Indochine Apparel (Bangladesh) Limited, Plot 54-56 (Previously Baxter Brenton (BD) Clothing Manufacturing Co. Ltd (Extension)

Plot-54-56, DEPZ (Old Zone), Ganakbari, Ashulia, Savar, Dhaka

9 September 2025

Observation-1: Substructure retrofitting works need to be verified & assessed (Building-1)

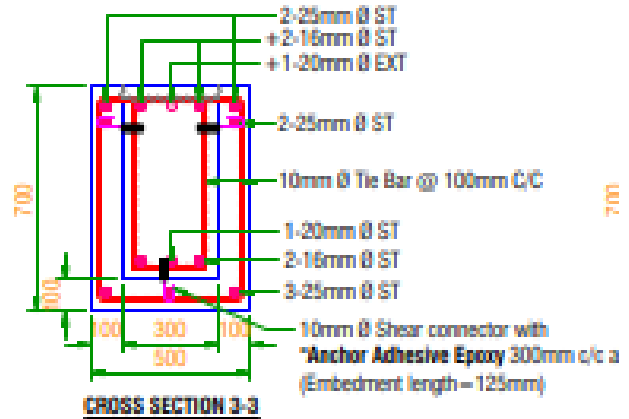
Pile cap retrofitting

Grade beam retrofitting

Description: Several pile caps and grade beams are shown as retrofitted in the as-built drawings; however, the factory could not provide pictorial evidence, QC certifications, or adequate test reports for the works, except for one verified pile cap of five piles. The Building Engineer is required to verify all substructure retrofitting works.

Item No.	Observation	Action Plan	Timeline
1.	Substructure retrofitting works need to be verified & assessed (Building-1)	Verify retrofitting works of substructure	within 6 weeks

Observation 05: Non-structural elements were found not anchored or braced. (Building-1)

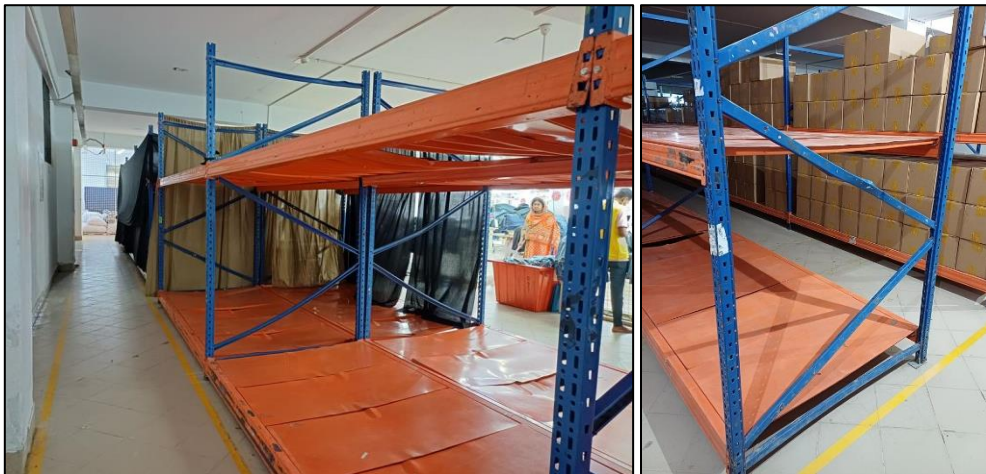
Description: During inspection, non-structural elements like the plastic water tank on the stair roof and storage racks on several floors were found not anchored or braced. The building engineer is required to anchor or brace all non-structural elements.

6.	Non-structural elements were found not anchored or braced. (Building-1)	The building engineer is required to anchor or brace all non-structural elements.	within 6 months
